The combination of these shortcomings makes the CBI vulnerable to PSE's manipulation, turning Customer Benefit Indicators into **Corporate Benefit Indicators**. To illustrate this concern, we provide a specific example of how PSE may have turned this CETA requirement to the company's advantage.

CBIs stacked against batteries

Lake Hills substation with potential Tesla Megapack battery locations shown in orange

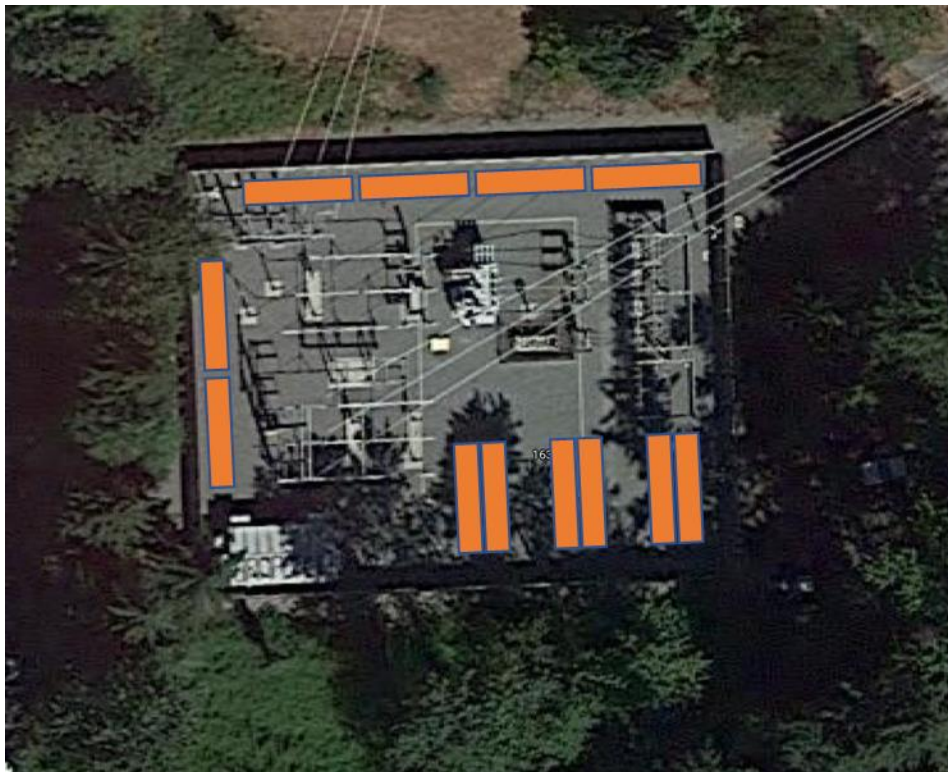
For example, consider the Lake Hills substation in East Bellevue, which contains four circuits serving a total of 5,500 customers in 2020. The substation has enough extra space to accommodate 12 Tesla Megapack batteries, capable of delivering a total of 18 MW for two hours. That would be enough to cover two hours of the 2024 peak demand on the Lake Hills substation predicted in 2018 WECC base cases (12 MW in a “heavy summer” scenario, 18 MW in a “heavy winter” scenario). The following photo shows a possible configuration of the batteries with standard spacing. (The dimensions of the Lake Hills substation are 135' x 100', and each Megapack is 23.5' x 5.5'.)

Although there is room for 12 Megapacks, it would be expensive to use batteries to cover 100% of the substation’s maximum load. Instead, consider the benefit of covering summer peak demand for any one of the substation’s circuits for two hours. That would require only four batteries at a cost of \$4.5 million. The batteries would provide some protection from power outages, some resiliency during emergencies, and cost savings by time shifting cheap renewable energy to serve peak hours.
